NO-02-0050
March 21, 2002

**SUBJECT: Quality Assurance Program (QAP) Topical Report - Millstone Power Station
Revision 23, Change 7 (Document No. MP-02-OST-BAP01)**

Summary of Changes to QAP Rev. 23 Incorporated as Change 07

Organizational Relationship
of Functional Groups Having Quality
Functions for Millstone
Power Station

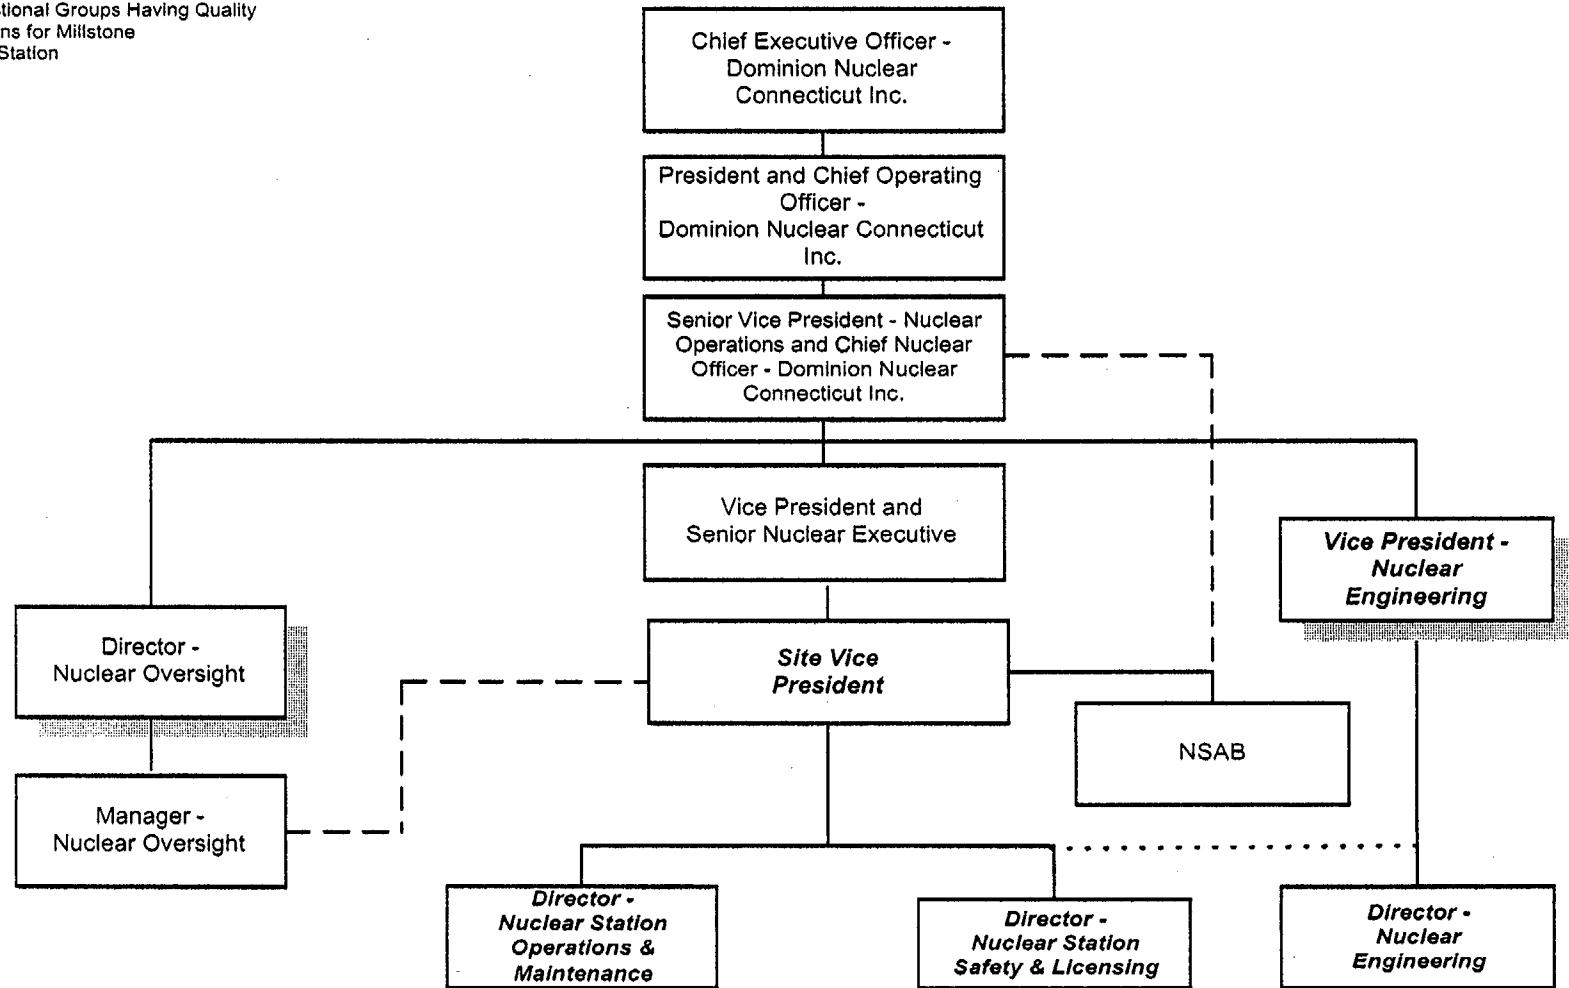
<u>Section</u>	<u>Summary Description of Changes</u>	<u>Reference</u>
Section 1.0	Modified Sections 1.3.7 and Figure 1.1 to eliminate the augmented Certified Fuel Handler position on Unit 2, completing transfer of responsibility of Unit 1 SPF and related systems to Unit 2 Operations.	Request 02-03
